KMR.CDD.RaQ.1921.01

ORDER UNDER SECTION 96 (2) OF ACT, III OF 1901.

Mr. Premji Ranchore is informed
that the plan submitted by him for building a hallon plot No. 152 Survey Sheet E6
situate in Pitamber Street, RamsawaniQuarter, is approved, and permission to build in accordance therewith is
granted. The building to be erected subject to the By-laws and Rules of the
Municipality.D. Banington Bros.
M. E. A. M. I. M. E. E.Acting Engineer,
Karachi Municipality.

PLAN OF PROPOSED CABIN & FAC

GROUND FLOOR PLAN

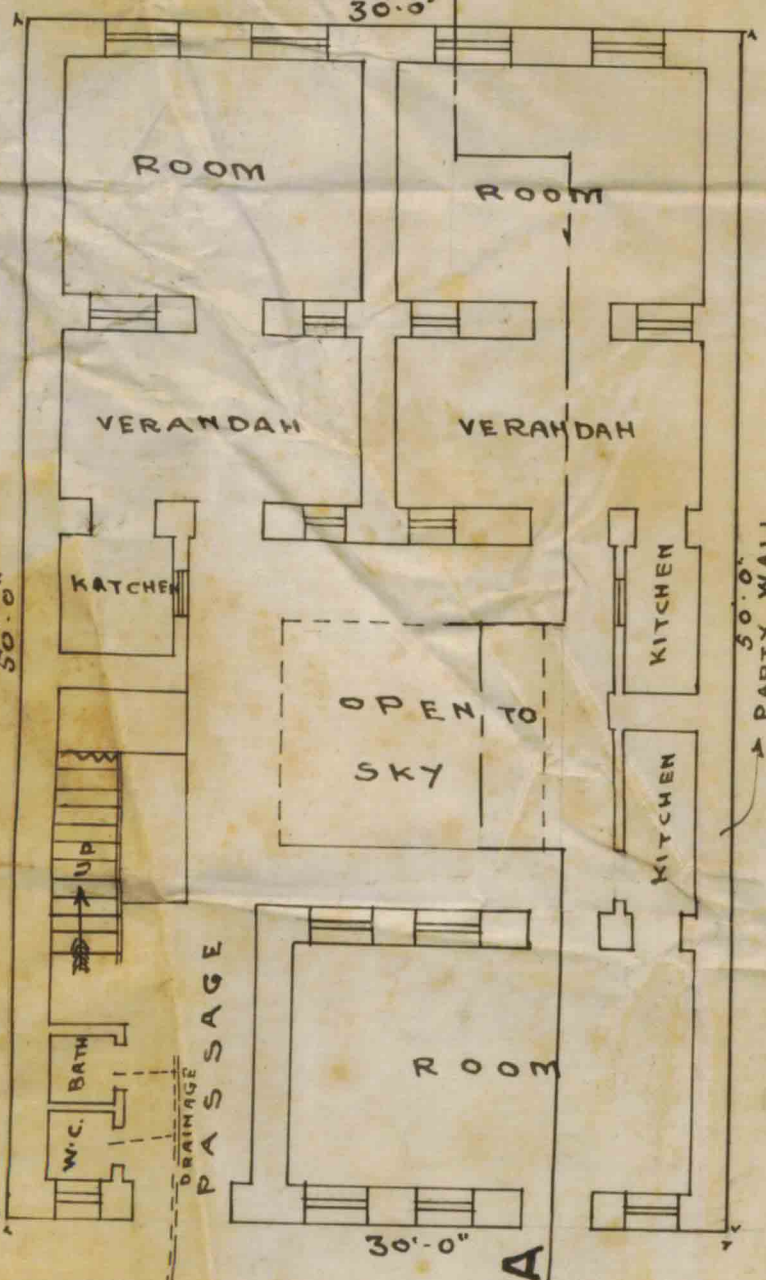
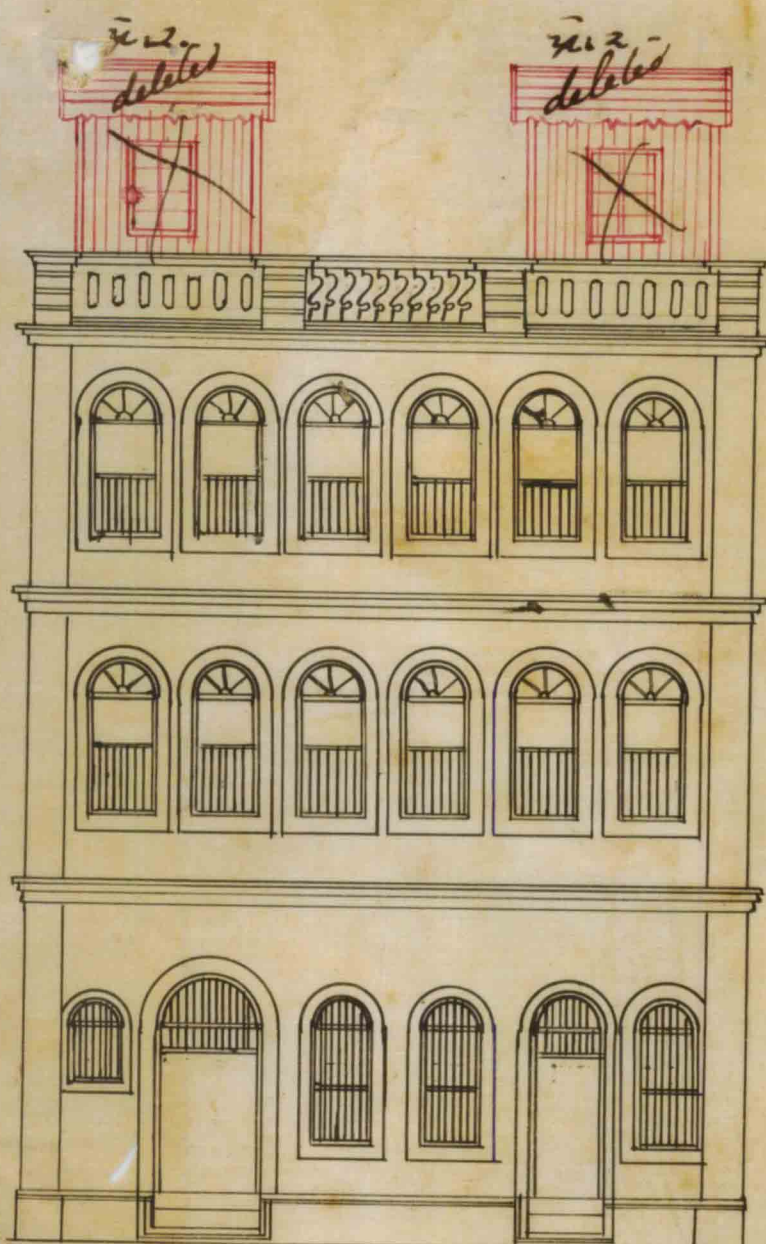
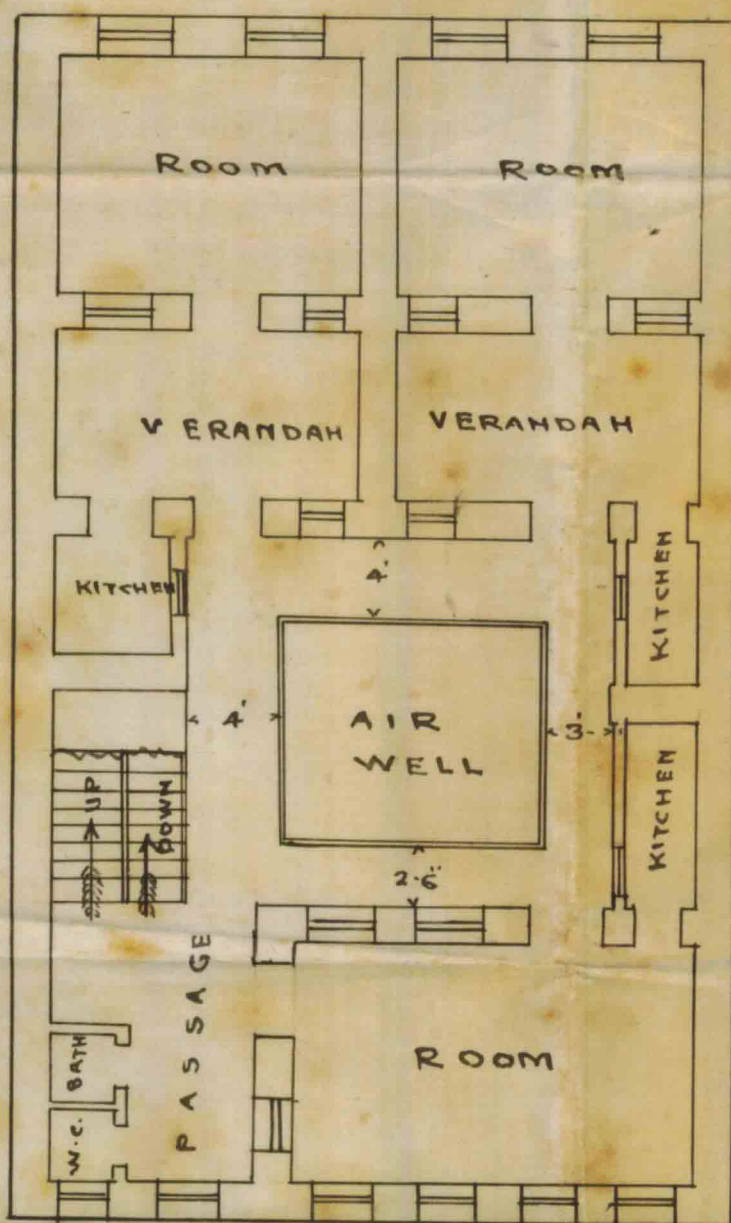
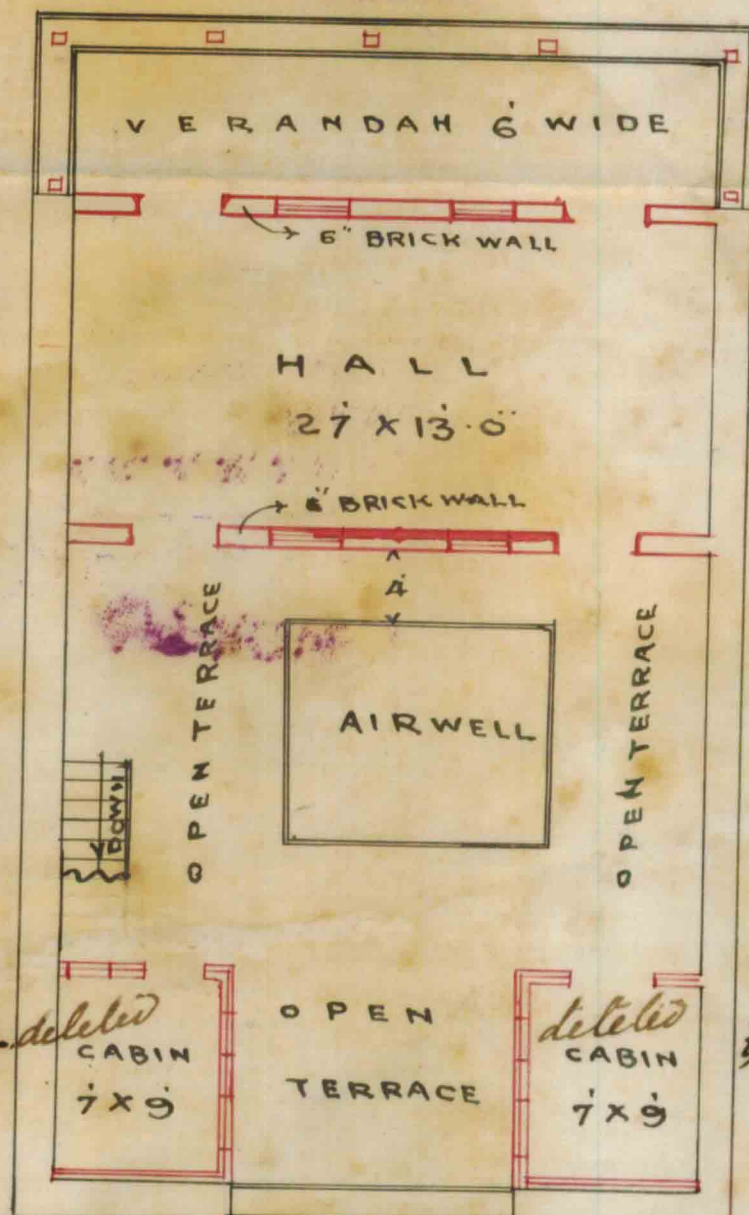
With reference to his application dated 3rd Instant with a plan for the proposed cabins on plot No. 152, E-6 Ramswami Quarter Mr. Premji Runchore is informed, the -- cabins are contrary to Byelaws and can not be permitted.

*Two Cabins Contrary to the
m/c rules have been deleted
There appears no objection
to approve the plan now.*

7' x 5' size cabins cannot be
permitted under rules

NoThe front two Cabins 7x9' cannot be
permitted, being contrary to rules.

Remarks See sheet report that other cabins
are contrary to the rule cannot be permitted.

The plan is returned here-with disapproved.

Not approved
